b. **Consideration of resolution #2021-25 for Final Site Plan approval of proposed Cheddar's Scratch Kitchen, property located approximately 4171 South Riverdale Road, Riverdale, Utah 84405; as requested by Riverdale Center North, LLC/Cheddar's and AWA Engineering Group.**

Final Site Plan Review – Cheddar’s Scratch Kitchen, 4171 South Riverdale Road

Plan Review For Cheddar's

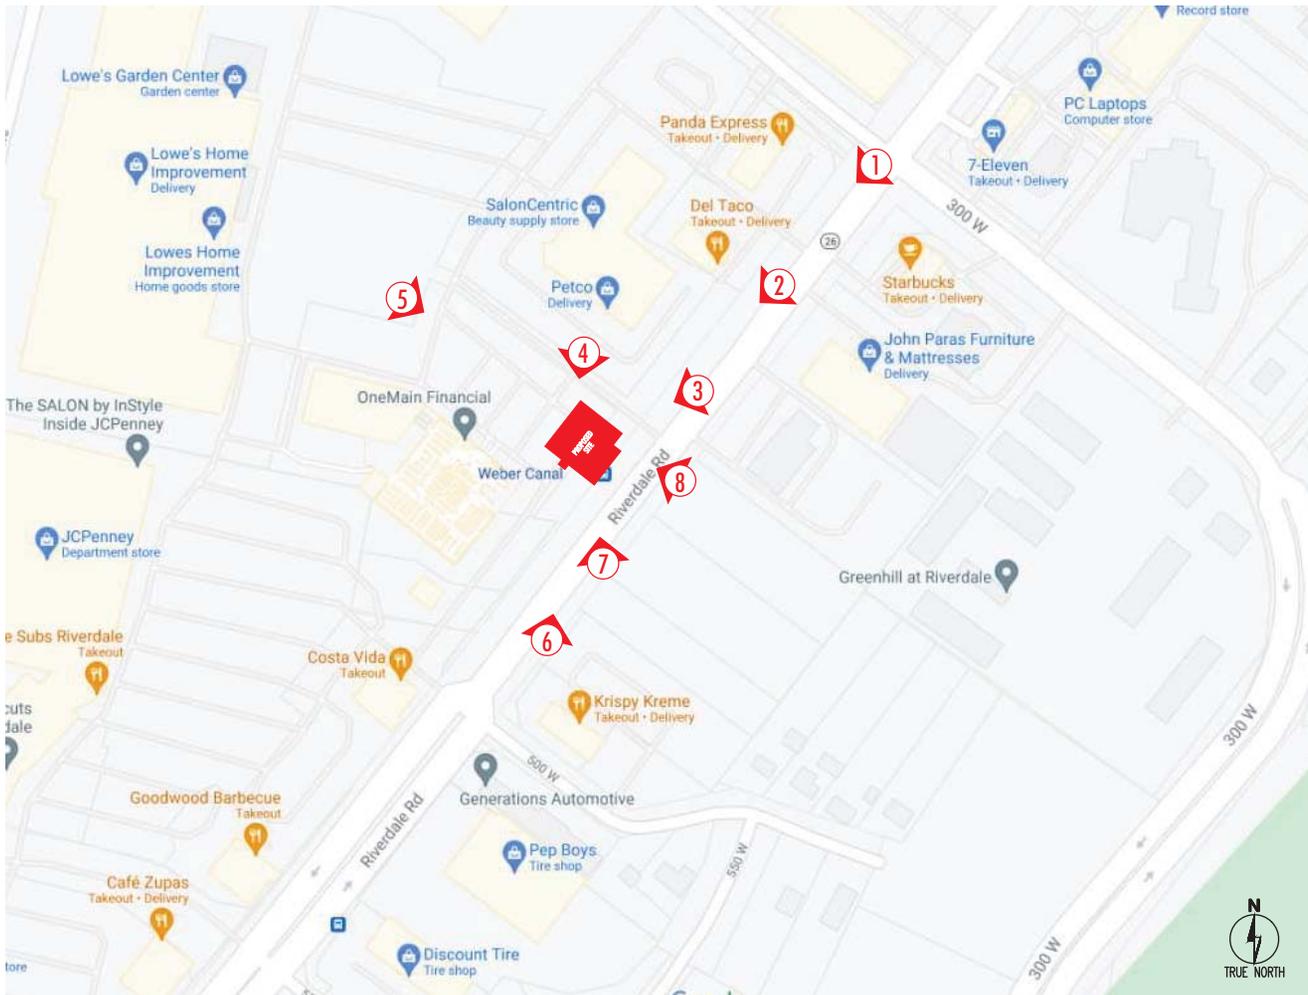
Possible proximity issue with new proposed pylon location in conjunction with future Dutch Bros. pylon.

There are other obstructions like trees, lanscape, and bus stop along Riverdale Rd. that will need to be adjusted and taken into consideration. we recommend removing or adjusting landscaping at southeast corner

As well as trees along Riverdale Rd.

19 Oct, 2021
 SHEET NO.
C1.0

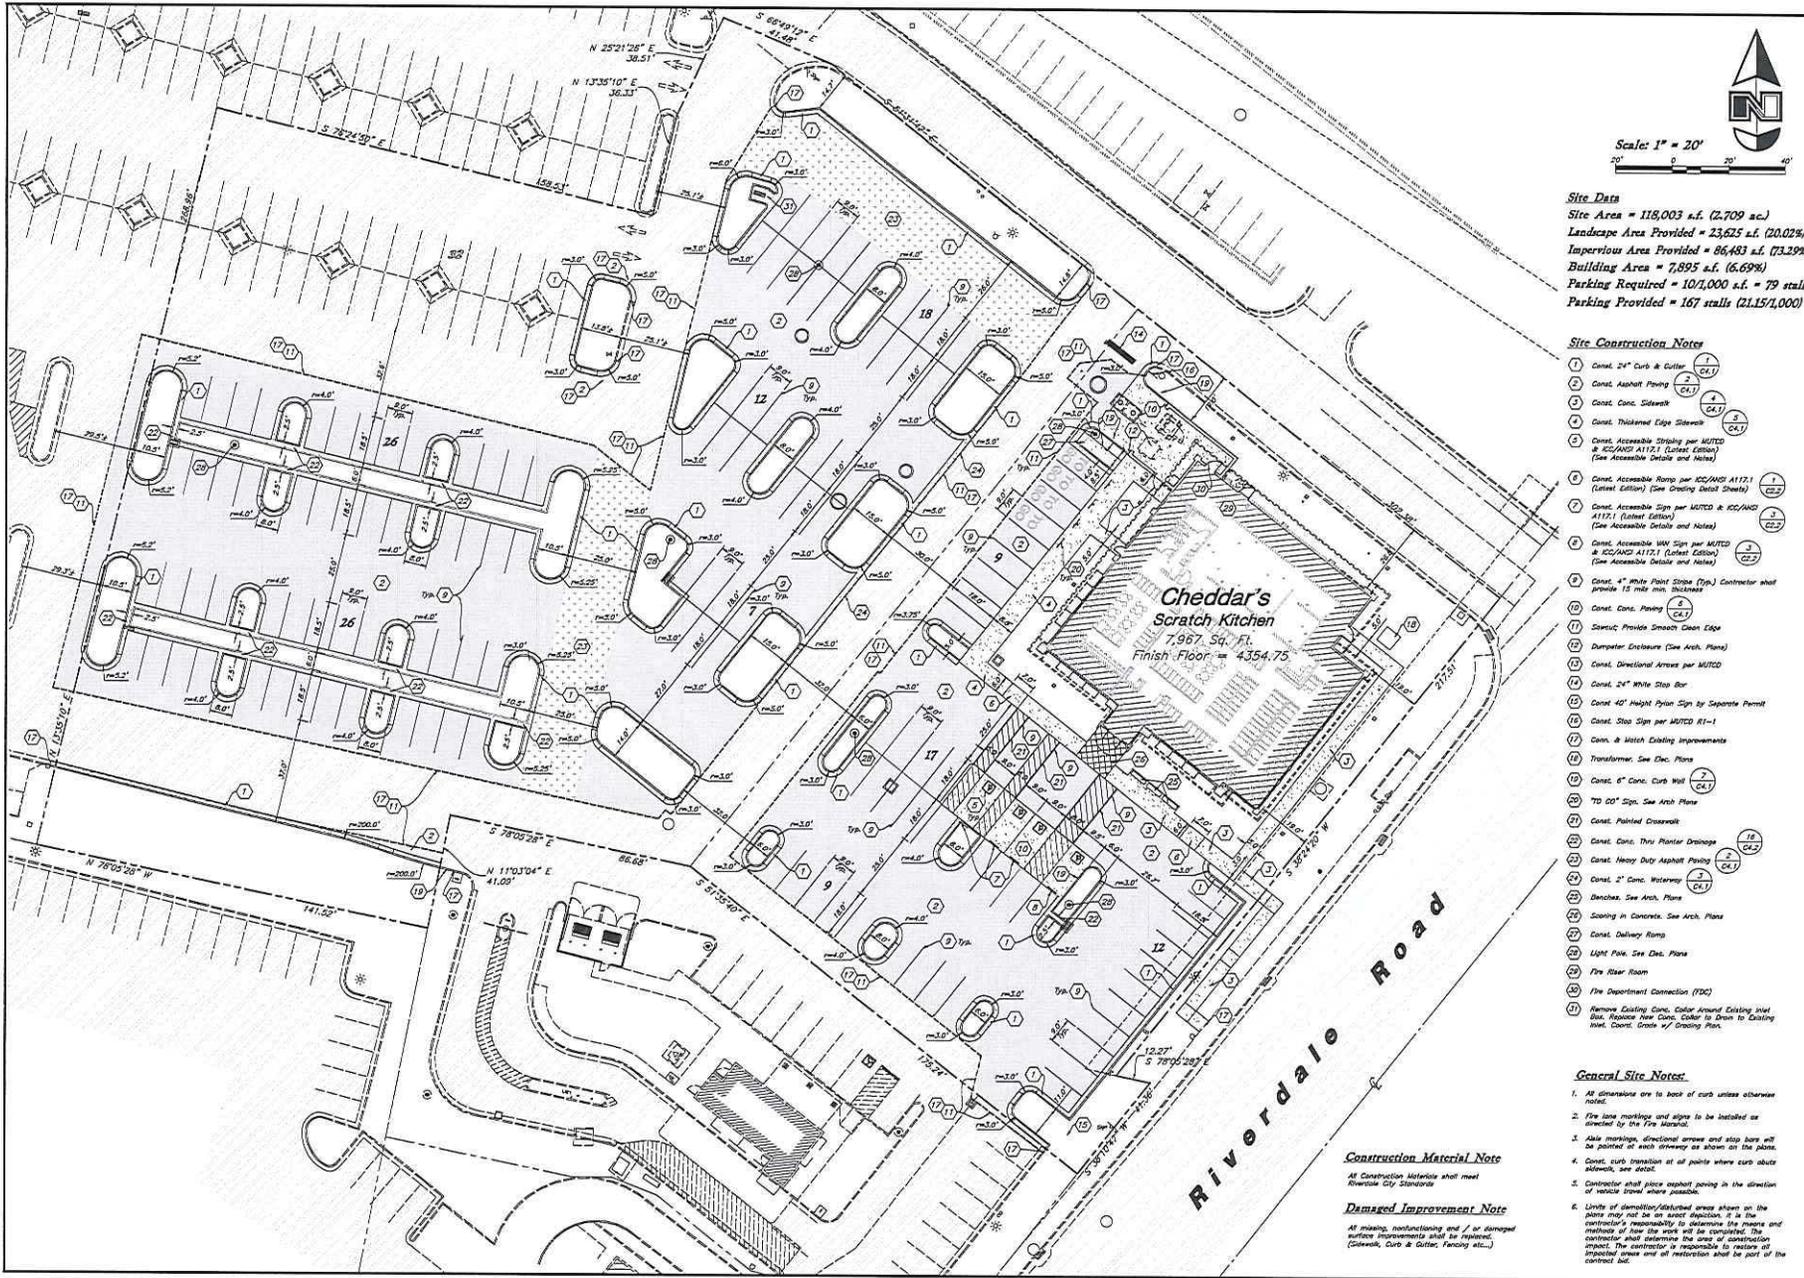
1-Storm water prevention plan for construction site including BMP's. All storm water inspections will need to be completed on Compliance Go. With the Dutch Bros now open the proposed plan doesn't work. Further discussion will be required.
